Response to anonymous referee #1's interactive comment on the manuscript "Measurements of dust deposition velocity in a wind-tunnel experiment"

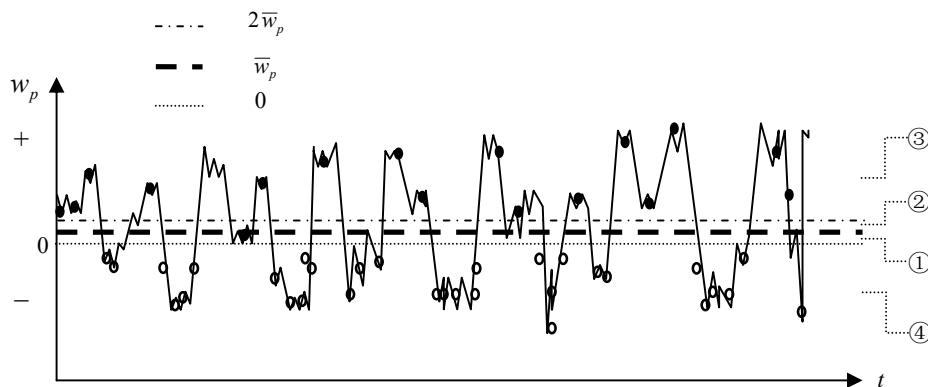
17. Fig. 7: Since the circled numbers 1 and 2 are larger than the thickness of the corresponding layers I would add a short line (“arm”) to the circles, pointing to the corresponding layer.

Response: The figure will be improved as shown below:

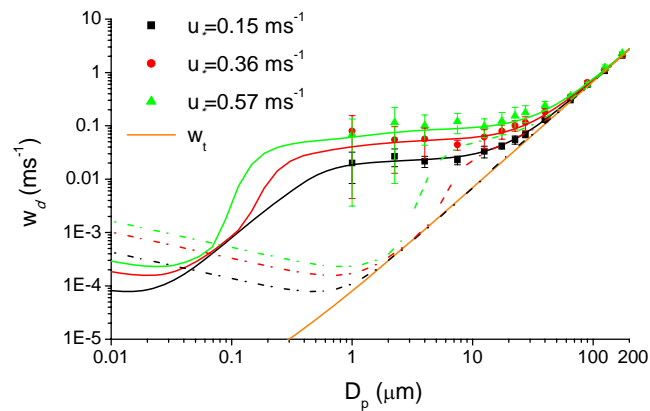
18. Lines 261-262: It is very unfortunate that the raw SS80 data are not shown. According to my calculations, the deviations with the authors’ measured deposition velocities should be really large. For example, for 1- μm particles and $u^* = 0.57 \text{ m/s}$ and $z_0 = 0.31 \text{ mm}$, SS80 predicts a deposition velocity two orders of magnitude lower than what the authors measured. The Sehmel and Hodgson (1978) model also predicts much lower deposition velocities, very comparable to SS80.

Response: we agree that the predictions of SS80 without considering particle growth effect (i.e. the case of $\text{RH}=0\%$, as shown below) are seriously lower than our measurements. But if particle growth is considered ($\text{RH}=100\%$), the predictions agree with our measurements very well. As we known, the dust we used is insoluble in water, and does not satisfy particle growth mechanism involved in SS80. So the good agreement should be a coincidence. This result indicates that the surface resistance is really low, which should be caused by the contribution of waves and spray droplets but enhanced terminal velocity of grown (larger) particles. Because this is not the topic of this paper, we directly set the surface resistance to zero (i.e. $1/w_D=0$) in this paper.

In other words, SS80 only suits for calm water surface. The distinct deviations between SS80 and our measurements should be caused by ignoring effect of waves and spray droplets in the model.
